FIN 2004-02

Fisher Information Notice: FIN 2004-02

Fisher Pneumatic Instrument Relays with Nitrile Elastomer Diaphragms

Figure 1. Diaphragm Locating Tabs

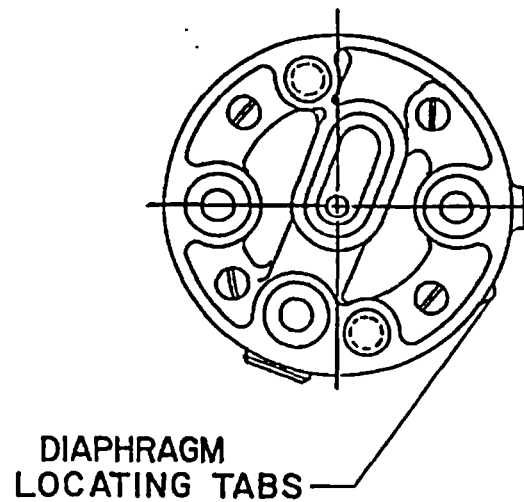
In February 1999, Fisher increased the thickness of the nitrile diaphragms in the Type 83 Series relays as part of a material consolidation program

Recently, Fisher was notified that the installed performance of several Type 3582 Positioners did not appear to be acceptable because of reported "sluggish" relay behavior. The most notable characteristic of this behavior is an increase in time required to exhaust the actuator diaphragm case (stroke time).

One can determine which type of nitrile diaphragm is present in a given relay by looking at the alignment tabs (See Figure 1) on the diaphragms that extend outside the relay segments:

- The thicker diaphragms are identified by red dots, or red (or pink) wavy lines, or light blue wavy lines.
- The thinner diaphragms are identified by white dots or white wavy lines. This is the same marking used for the pre-1999 diaphragms.

To correct this problem, Fisher has reduced the thickness of the nitrile diaphragm to its previous, thinner dimensions. Table 1 provides a conversion list for replacement part numbers.
